72+COLLINS HOTEL & CONDOMINIUM

CITY OF MIAMI BEACH DESIGN REVIEW BOARD

FEBRUARY 2, 2021

GROUND LEVEL- PHASE 2

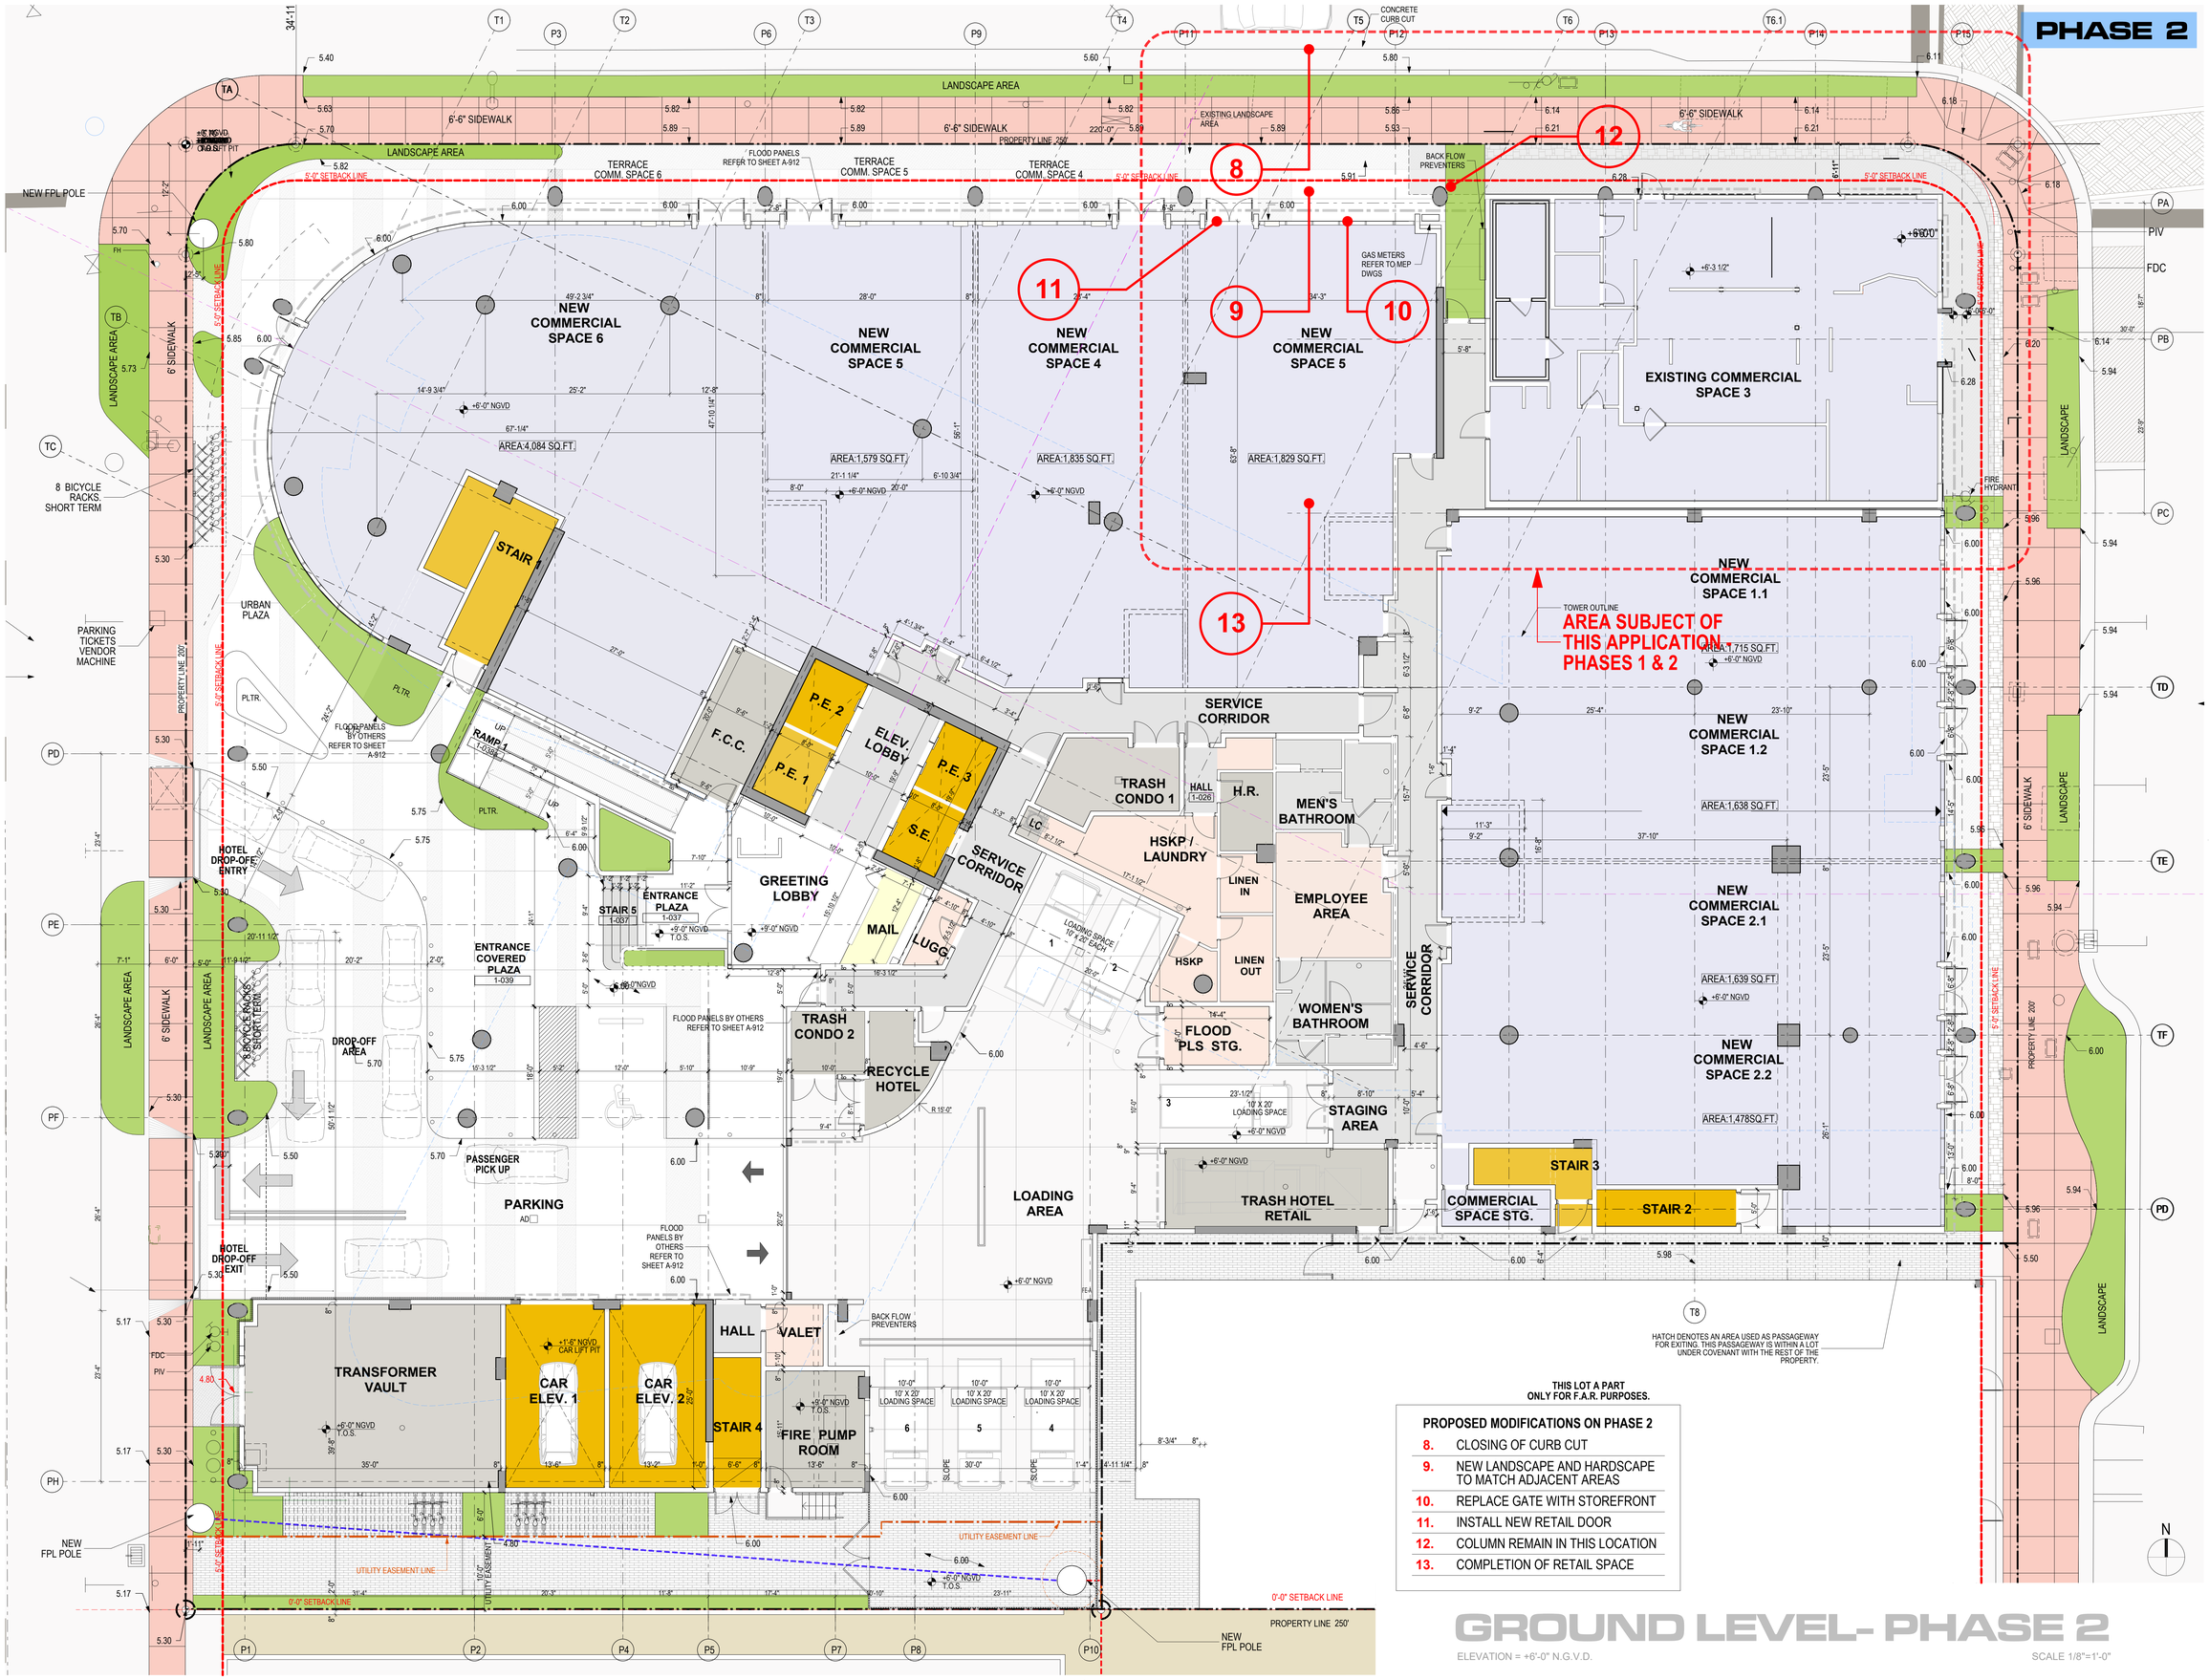
TO TEMPORARILY LEAVE AND INCORPORATE THE SMALL PARKING LOT BEHIND DENNY'S INTO THE APPROAVED PROJECT DURING THE TERM OF THE DENNY'S LEASE AND THEN FILL IN THE PARKING LOT WITH RETAIL SPACE AFTER THE DENNY'S LEASE IS OVER.

LEGEND - PROPOSED CHANGES

5 SHIFT OF THE SOUTH EDGE OF THE BUILDING IN THE WEST HALF OF THE PROJECT SIX (6) FEET TO THE NORTH, THERE IS NOW 16 FEET BETWEEN THE PROJECT AND THE ADJACENT BUILDING TO THE SOUTH.

6 PLACEMENT OF ADDITIONAL SHORT-TERM BICYCLE RACKS.

7 RECONFIGURATION OF ENTRANCE PLAZA.

8 RECONFIGURATION OF URBAN PLAZA.

9 CONTINUOUS PLANTING BED ALONG SIDEWALK.

PARTIAL GROUND LEVEL FLOOR PLAN | 1

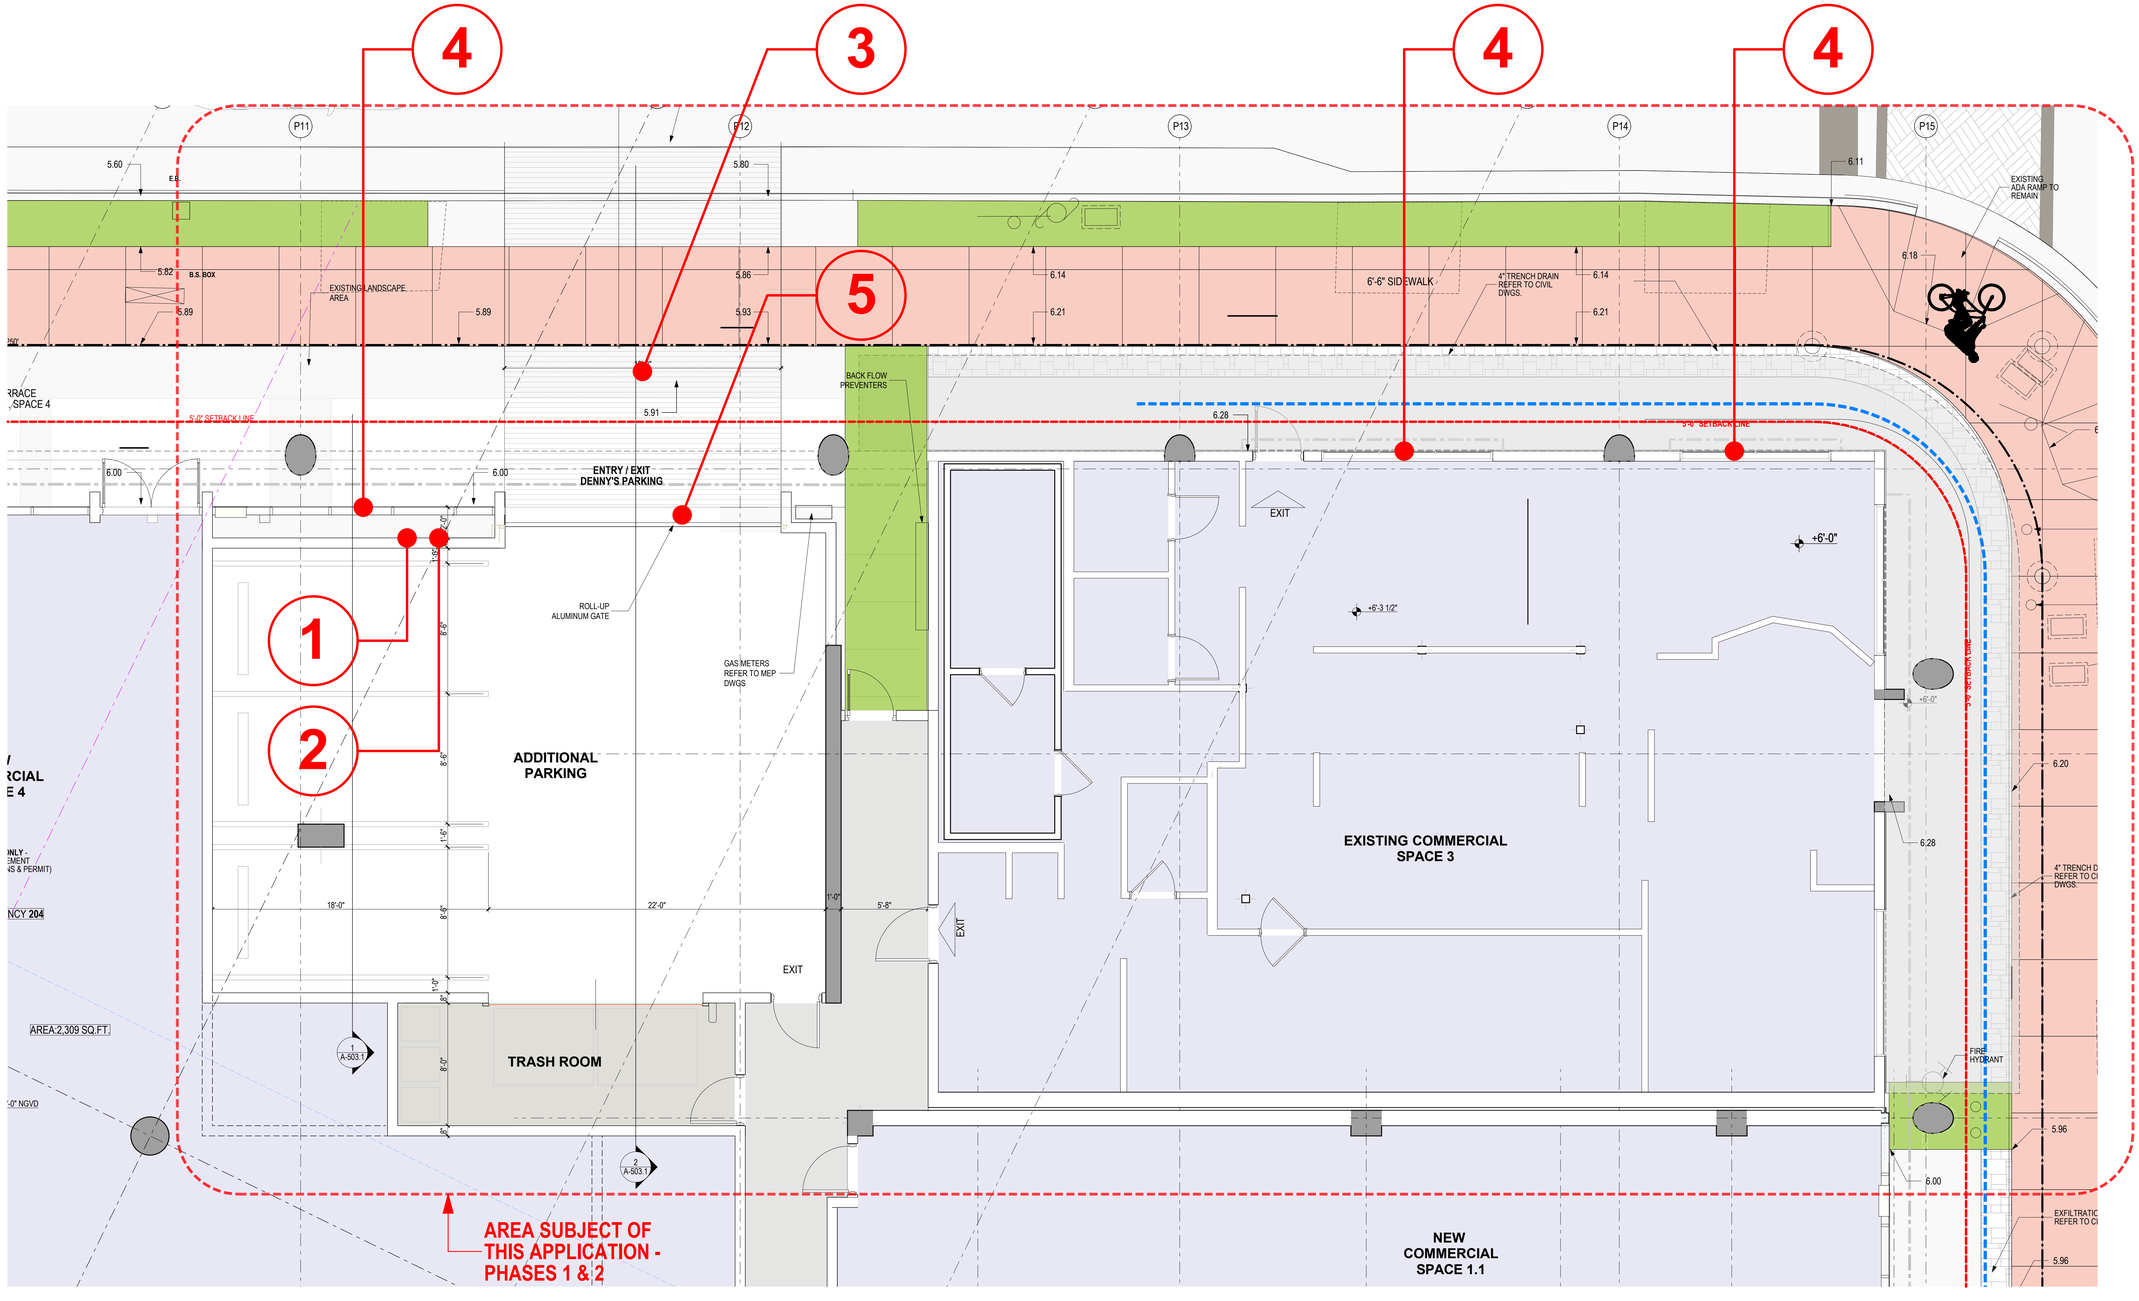
ALL OF THE VARIANCES ARE ONLY REQUIRED FOR THE **TEMPORARY PHASE 1** IMPROVEMENTS TO ACCOMODATE THE DENNY'S LEASE.

1. SEC. 142-745 (e)(2)(b). EXCEPT WHERE REQUIRED FOR DRIVEWAYS AND UTILITY INFRASTRUCTURE, THE GROUND FLOOR SHALL CONTAIN HABITABLE SPACE WITH A MINIMUM DEPTH OF 50 FEET FROM BUILDING FACADE. **2 FT PROVIDED.**

2. SEC. 142-745 (e)(2)(e). GROUND FLOOR AND SURFACE PARKING SHALL SETBACK A MINIMUM OF 50 FEET FROM THE BUILDING FACADE AND BE CONCEALED FROM VIEW FROM THE CLEAR PEDESTRIAN PATH. **2 FEET PROVIDED.**

3. SEC. 142-745 (e)(3). DRIVEWAYS AND VEHICLE ACCESS TO OFF-STREET PARKING AND LOADING SHALL BE PROHIBITED ON CLASS A FRONTAGE, UNLESS IT IS THE ONLY MEANS OF EGRESS TO THE SITE. **ONE DRIVEWAY PROVIDED ON 72 STREET, WHIS IS A CLASS A FRONTAGE.**

4. SEC. 142-745 (a)(8)(b). FRONTAGE FOR COMMERCIAL, HOTEL, AND ACCESS TO UPPER LEVEL FRONTAGE SHALL CONTAIN A MINIMUM OF 70 PERCENT CLEAR GLASS WINDOWS WITH VIEWS INTO HABITABLE SPACE. **21.56 % PROVIDED.**

5. SEC. 142-745 (a)(10)(a). PARKING FACILITIES SHALL BE ENTIRELY SCREENED FROM VIEW FROM PUBLI RIGHTS-OF-WAY AND CLEAR PEDESTRIAN PATHS.

ELEVATION NORTH CORNER FACADE - PHASE 1

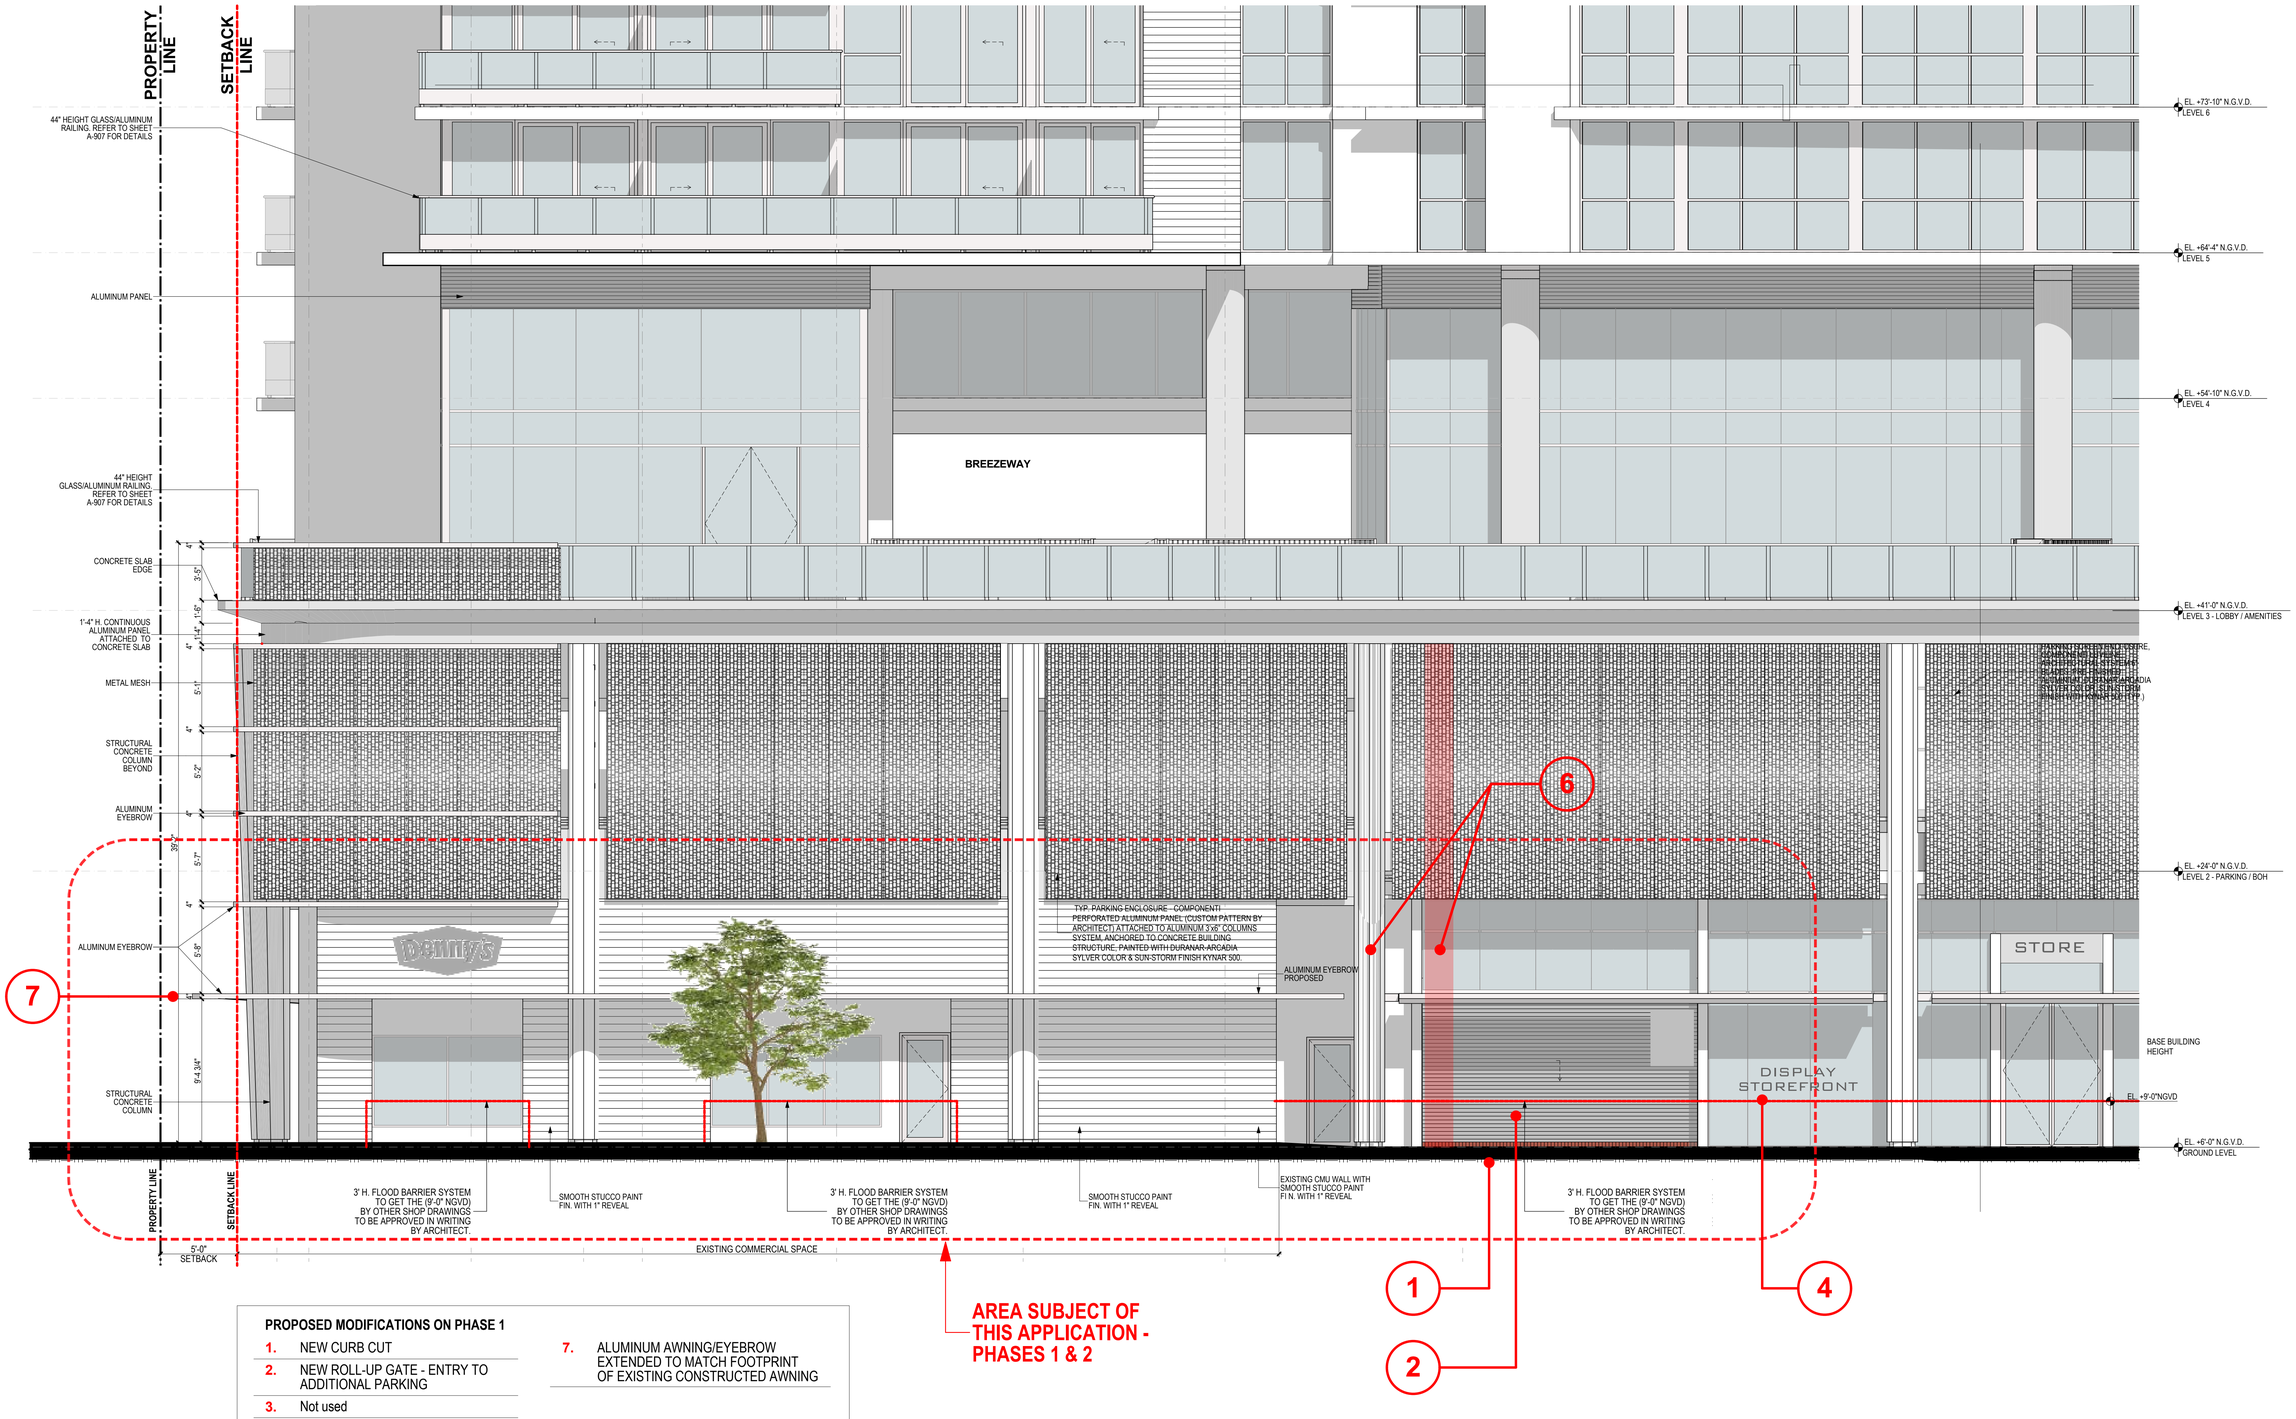
PROPOSED MODIFICATIONS ON PHASE 1

1. NEW CURB CUT
2. NEW ROLL-UP GATE - ENTRY TO ADDITIONAL PARKING
3. Not used
4. DISPLAY WINDOW
5. Not used
6. COLUMN RELOCATION
7. ALUMINUM AWNING/EYEBROW EXTENDED TO MATCH FOOTPRINT OF EXISTING CONSTRUCTED AWNING
